NOT FOR CONSTRUCTION - FOR PD SUBMITTAL ONLY

Rainbow Rascals Childcare
Lake Mary Blvd and east side of S. 5th Street
SITE LIGHTING PLAN

DATE: JULY 2017
PROJECT NO.: DSERAS01
DRAWN BY: NVA
CHECKED BY: NVA
SCALE: 1"=30'
SHEET: EL1

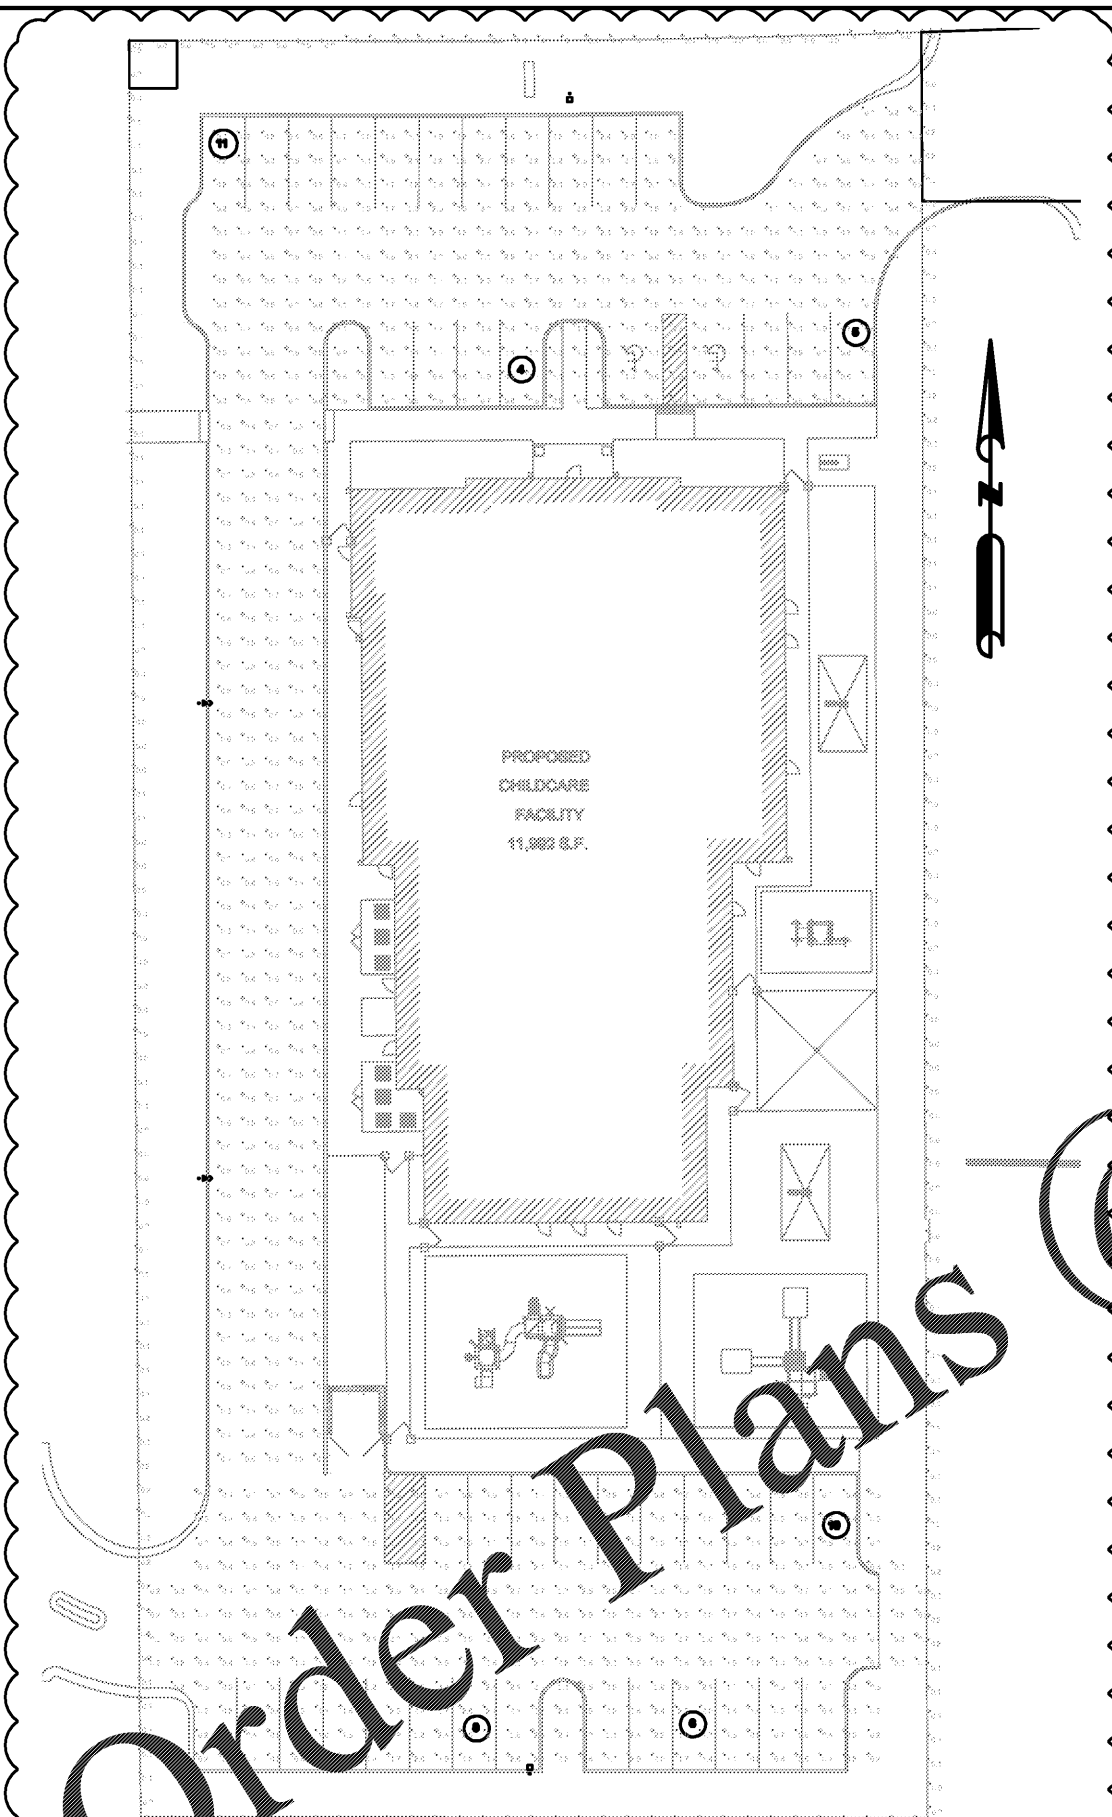
REVIS 60. THE SITE LIGHTING EXCEEDS 0.5 CANDLES AT THE PROPERTY LINE ALONG THE SOUTHWEST, SOUTHWEST AND NORTHEAST CORNERS OF THE PROPERTY.

REVIS 60. THE SITE LIGHTING EXCEEDS 0.5 CANDLES AT THE PROPERTY LINE ALONG THE SOUTHWEST, SOUTHWEST AND NORTHEAST CORNERS OF THE PROPERTY.

DIRECT BURIAL CONCRETE POLE DETAIL

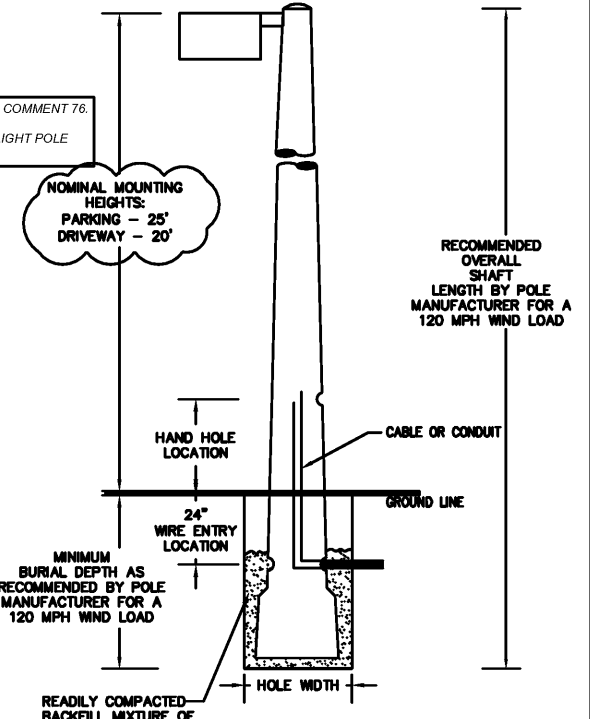
REVIS 76. MAXIMUM HEIGHT OF A LIGHT POLE IS 25'. PLAN SHOWS 30'.
